**George M. Janes & Associates Review of Visual Resources,
DEIS, April 22, 2009**

RE: SEQRA
Review of Visual Resources &
Community Character
CPV Valley Energy Center DEIS
Town of Wawayanda
Orange County, New York

Figure 1: Existing and simulated view from Paramount Theater. Stacks will be marginally visible through trees to the right of the apartment building at the center of the photograph

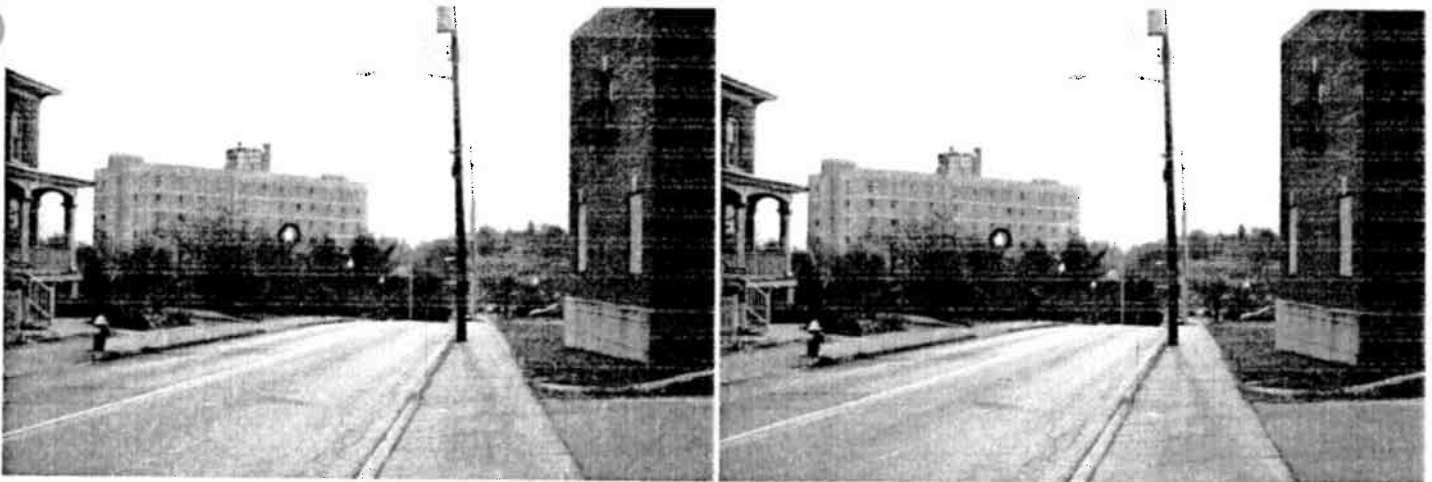
The project being proposed is both tall (with stacks at 275 feet) and massive in scale (with a substantial base 115 feet tall) when compared with other structures in the Town and County. Considering the height and overall scale of the project, however, the site selected for the project conceals it from most state and federally listed visual resources. Where there are views to the project from most of these resources (such as the Paramount Theater (Viewpoint 1)) the project is partially screened and distance has mitigated the scale of the project.

Figure 2: Existing and simulated view from Bike Route 17 (Route 6). Many near-field views will be experience significant visual impacts

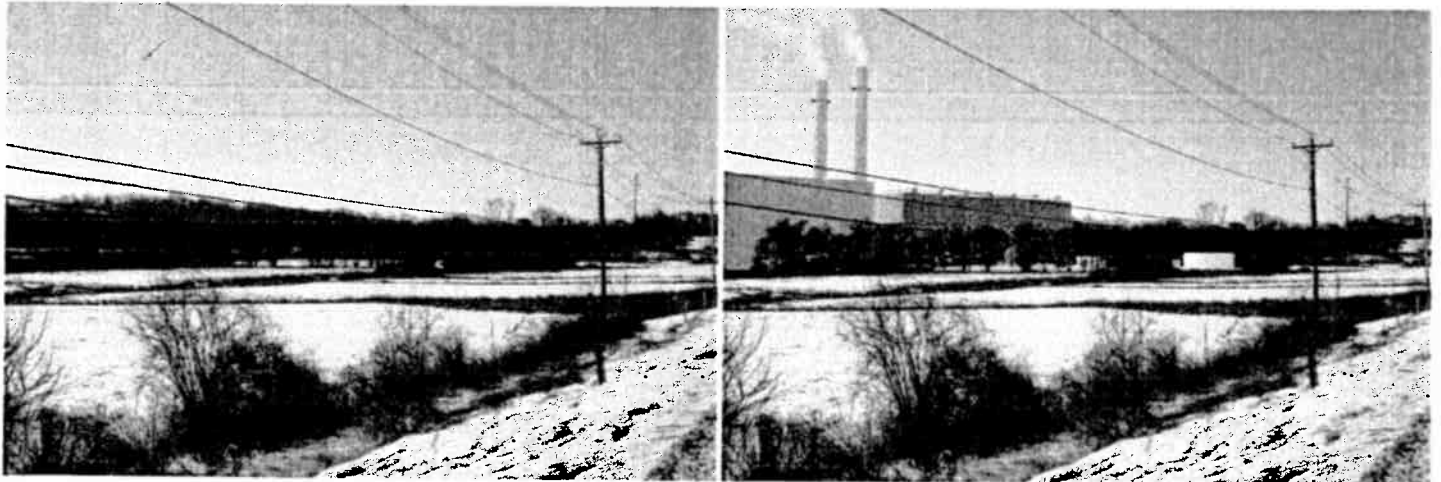
The listed resource that will experience the largest visual impact is New York State Bike Route 17:

This impact is disclosed in the DEIS as “significant unmitigateable visual impact.”

Figure 3: Existing and simulated view from I-84, Viewpoint 13.

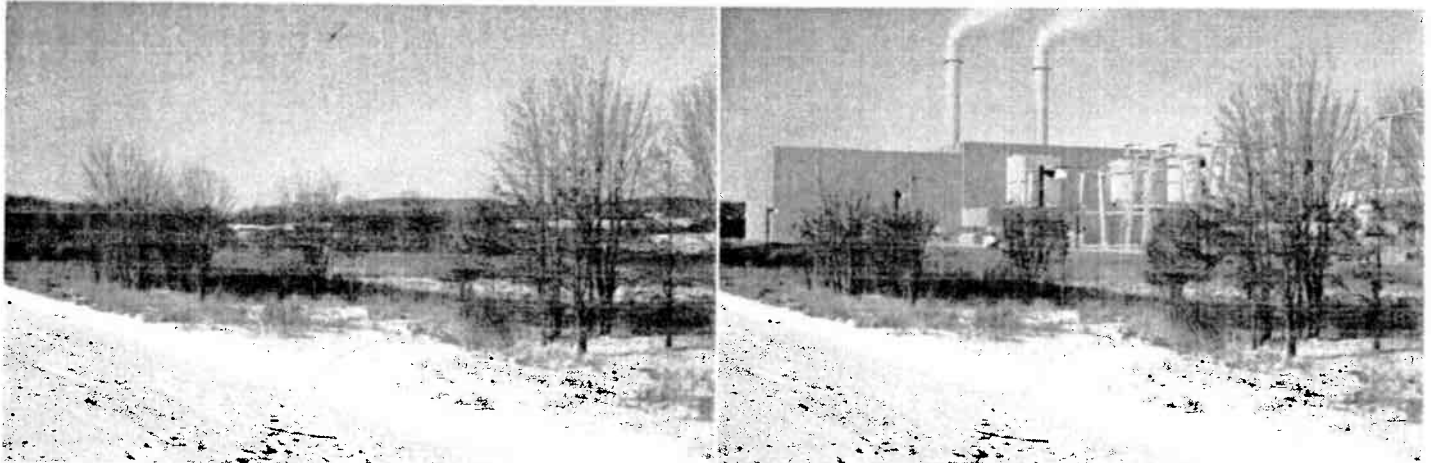
identified do not have views to the project and so do not experience visual impacts. Several near-field viewpoints do have visibility to the action and the photosimulations disclose, and the text describes, visual impacts from Viewpoints 5, 6, 10, 11, and 13, which is reproduced below:

From the near-field, side-of-the-road viewpoints, the action will create a dramatic change in the view. The action introduces a new form and use on the landscape which is dramatically different when compared to existing elements in the viewpoint. The action shows dramatic changes to the viewpoints analyzed in terms of form, line, texture and scale, and significant visual impacts. Despite the following inadequacies detailed below, the DEIS discloses significant visual impacts in these near-field viewpoints.

businesses.”⁸ Arguably the largest visual impact of the project is to travelers along I-84 (Viewpoint 13 reproduced as Figure 3 above) as they approach interchange for the Town and the City of Middletown. It does not appear that such a “first impression” reflects “the values of the residents and business” as described in the Comprehensive Plan.
